**Subject:** **Approval of a Contract for Traffic Signal Installation at the new Austin Elementary School**

# ITB 19-01: ROBERTS DRIVE SIGNAL INSTALLATION

## ADDENDUM #1, February 6, 2019

CHECKED:	DATE:	DRAWING No.
BACKCHECKED:	DATE:	27-0003
CORRECTED:	DATE:	
VERIFIED:	DATE:

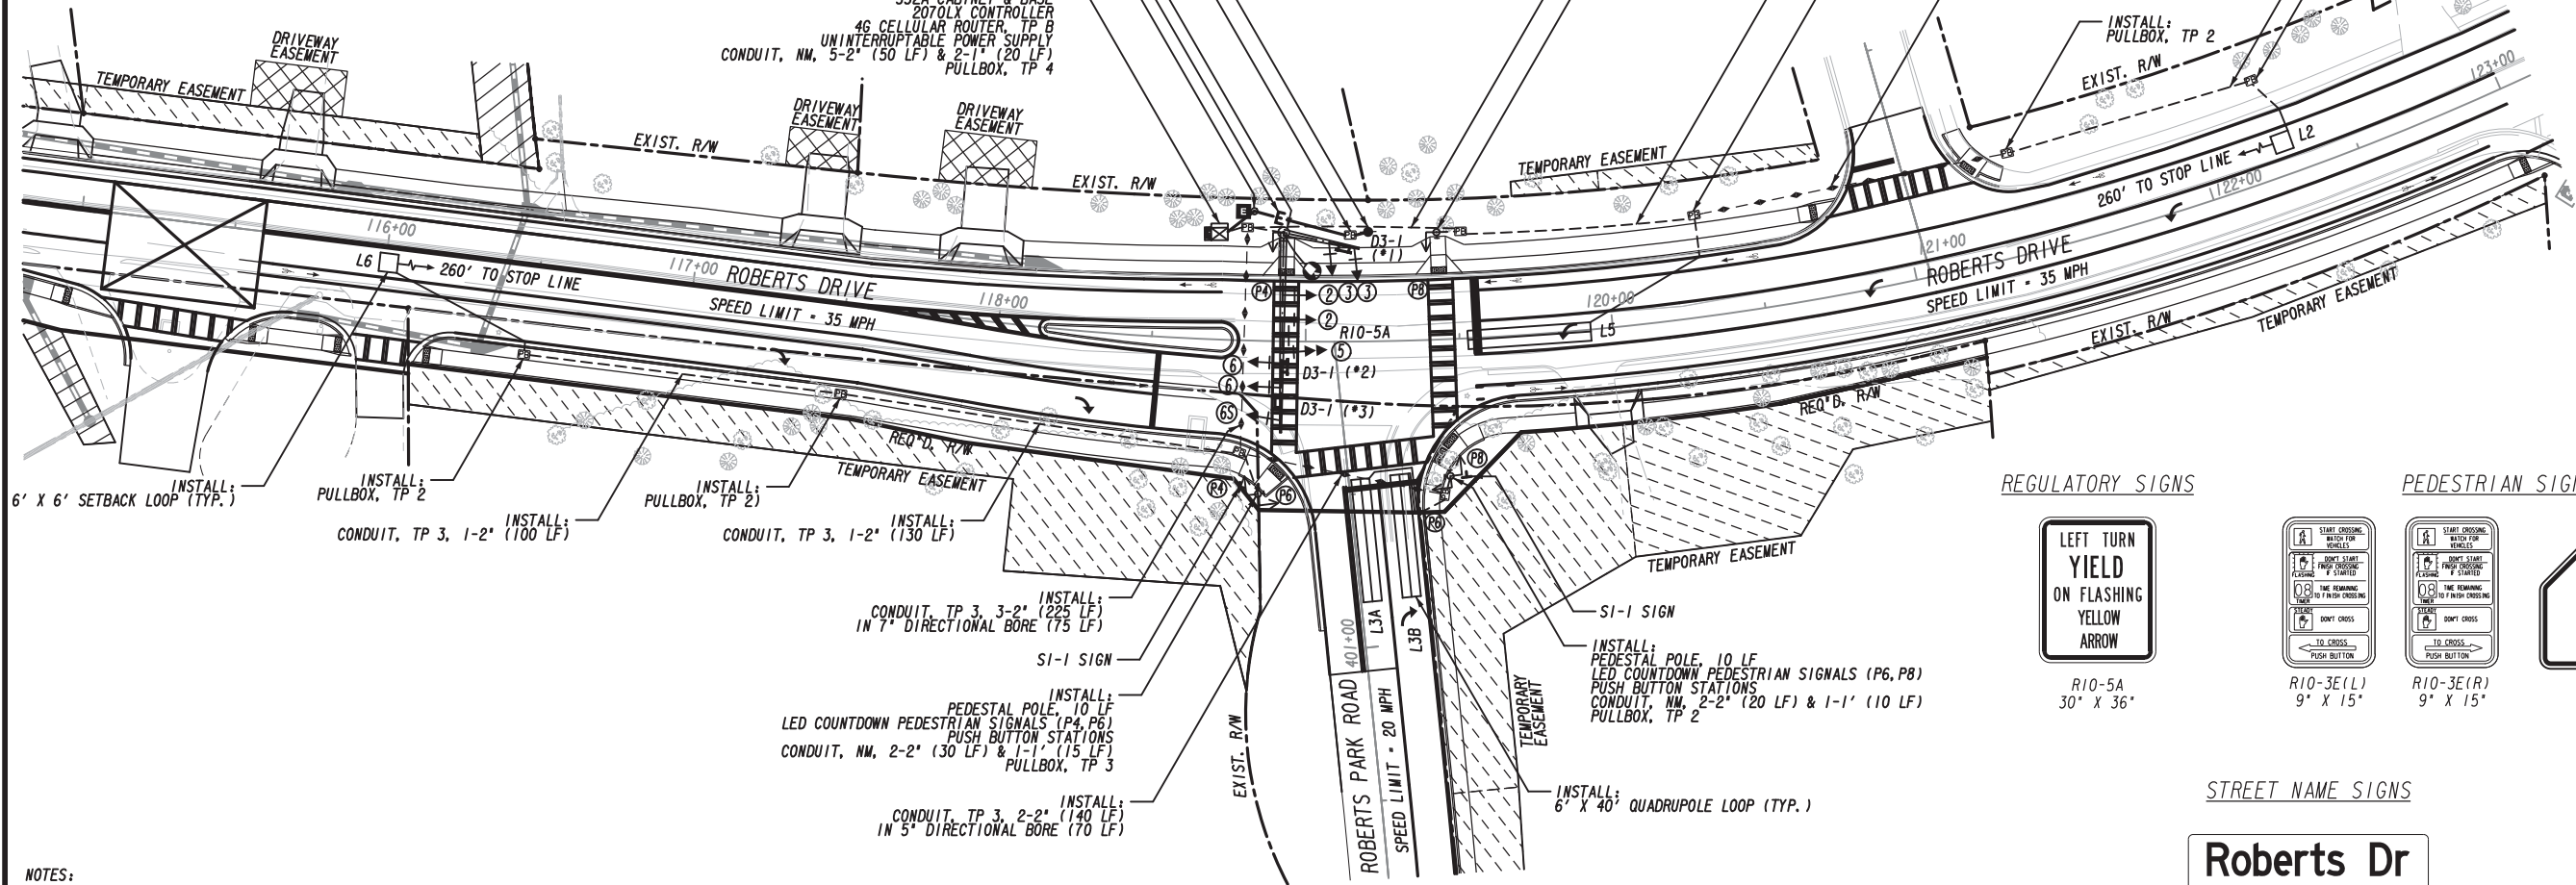
3. Is there enough space in the existing power panel for the additional circuit? **RESPONSE:** YES
4. Is there a particular brand or model of a 4G Cellular Router that the city prefers? **RESPONSE:** N/A. This device has been omitted from the plan.

5. Who is the city's service provider of cellular service for the routers? **RESPONSE:** N/A. The wireless router is no longer required due to fiber optic cable drop/extension from the adjacent traffic signal at Roberts/Chamblee-Dunwoody Road.

6. Please confirm that all post mounted signs are excluded from the traffic signal scope. **RESPONSE:** Bidders shall include the signs noted on Sheets 27-0003 (R10-5A, R10-3E(L), R10-3(R), S1-1 and D3-1 (1 thru 3)) and 27-0004.

CHECKED:	DATE:	DRAWING No.
BACKCHECKED:	DATE:	27-0006
CORRECTED:	DATE:	
VERIFIED:	DATE:

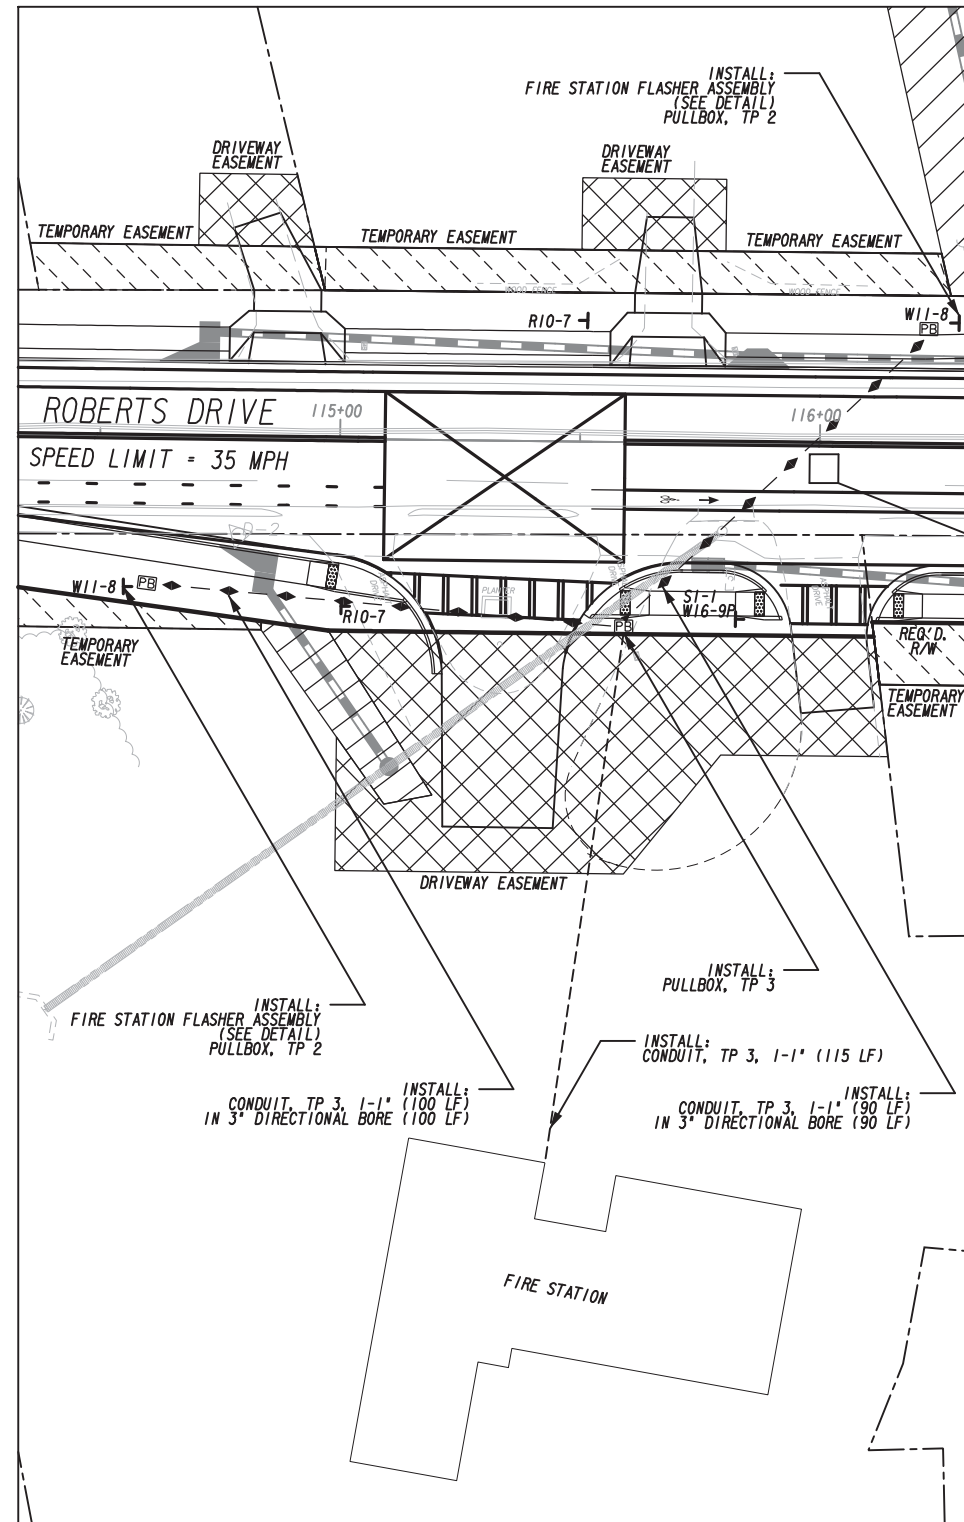
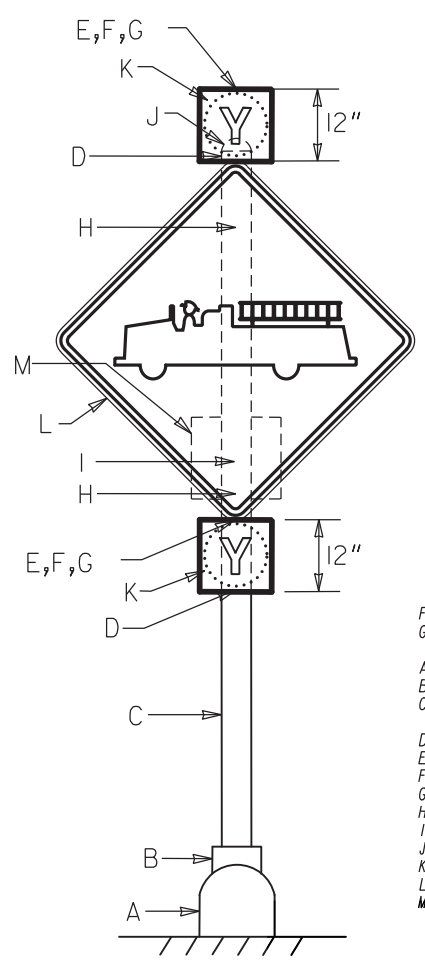
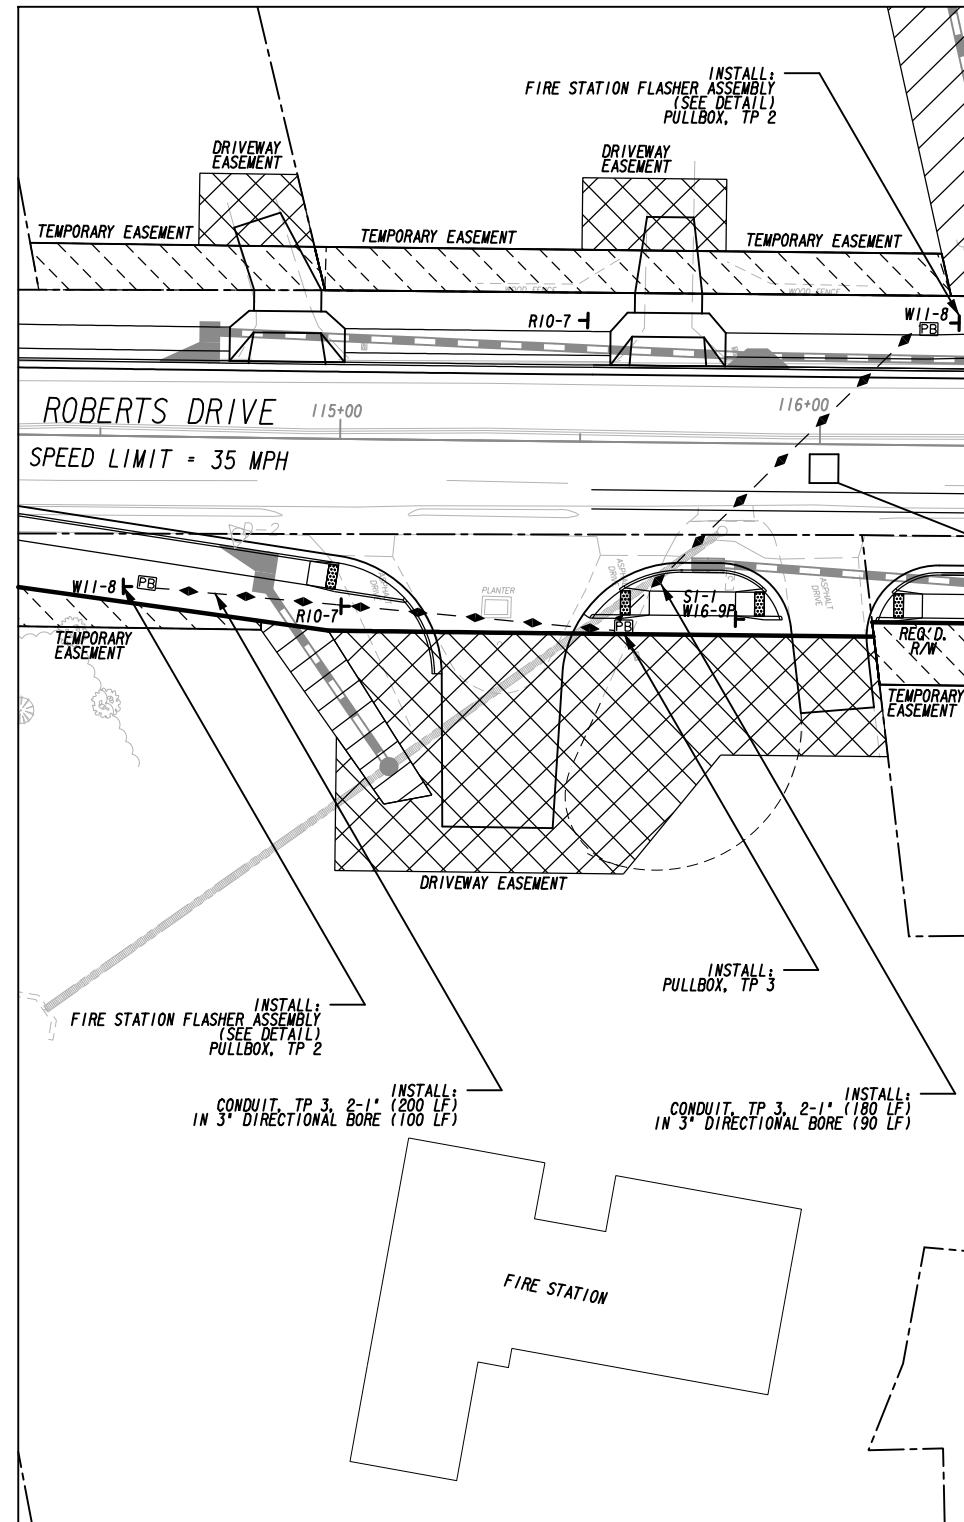
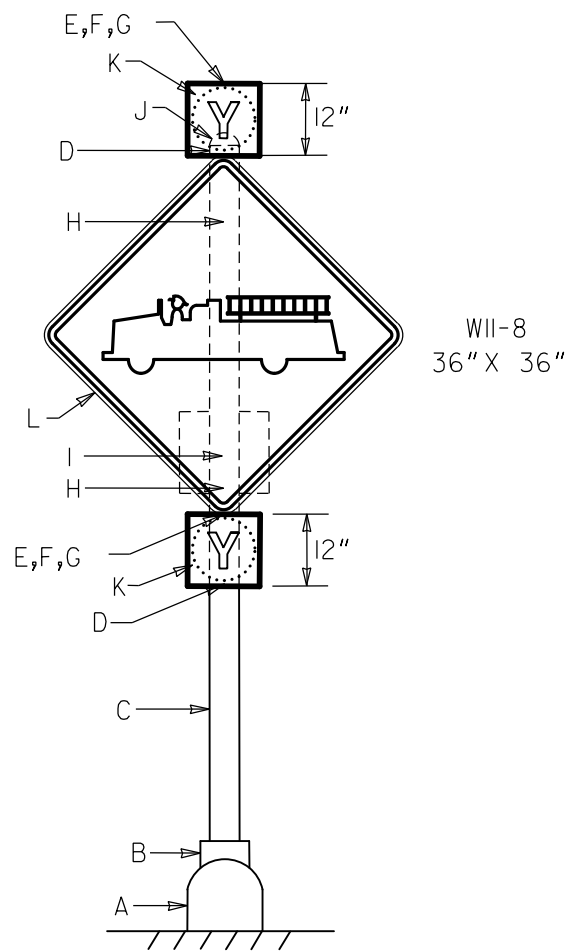
7. Please confirm if the city wants the fire station flasher poles are to black also. **RESPONSE:** YES.
8. Please confirm if the flasher time switch has to be pager programmable or will the city take in consideration a time switch that is not pager programmable? **RESPONSE:** This item has been removed from the project scope. Do not include in your bid proposal.

9. Please confirm that the CPR 2102 is the correct choice for this application. The CPR 2102 is a pager programmable time switch which is intended to run schedules. **RESPONSE:** This item has been removed from the project scope. Do not include in your bid proposal.

11. The fire station flasher assembly calls for a programmable pager (27-006). Can the city give us information on what programmable pager they need for this? **RESPONSE:** This item has been removed from the project scope. Do not include in your bid proposal.

12. For the fire station flasher assembly what is the desired power method and is there any information on where to get power from if AC is desired? **RESPONSE:** AC power will come from the signal cabinet via conduit. See drawing per Note 2 above.

14. The notes for the fire station flasher state the power breaker/disconnect shall be installed on the power pole. Is the contractor to establish a new service point for these flashers or install conduit to the service point for the traffic signal? **RESPONSE:** *The power for the flashers will come from the new signal cabinet.*

15. Where does the conduit to the fire station from the Pull Box, TP 3 terminate? **RESPONSE:** *The conduit to the fire station has been omitted.* Should a pull box be installed outside the fire station for termination by others? **RESPONSE:** *No.* Are the flashers to be push button activated in conjunction with the RTC programmable time switch? **RESPONSE:** *Yes. There will be a wireless push button mounted on the inside wall of the fire station at the truck bays. The RTC programmable switch has been omitted from the scope.*

- FIRE STATION FLASHER NOTES:**
1. THE TYPE OF PROPOSED FIRE STATION FLASHER SHALL BE APPROVED BY THE CITY OF DUNWOODY PRIOR TO PURCHASING AND INSTALLATION.
  2. THE POST SUPPORTING THE FLASHER SHALL BE POWDER COATED BLACK.
  3. THE FLASHER SHALL BE EQUIPPED WITH WIRELESS ACTIVATION CAPABILITIES, SIMILAR TO THE TAPCO BLINKER BEACON OR EQUIVALENT.
  4. THE FLASHING INTERVAL SHALL BE DETERMINED BY THE CITY OF DUNWOODY.
  5. POWER FOR THE FLASHER SHALL BE ROUTED BACK TO THE TRAFFIC SIGNAL CABINET AT THE INTERSECTION OF ROBERTS DRIVE AT ROBERTS PARK ROAD. THE CITY OF DUNWOODY WILL DETERMINE THE ROUTING OF THE CABLE AND CONDUIT TO CONNECT THE FLASHER WITH THE TRAFFIC SIGNAL CABINET IN THE FIELD.
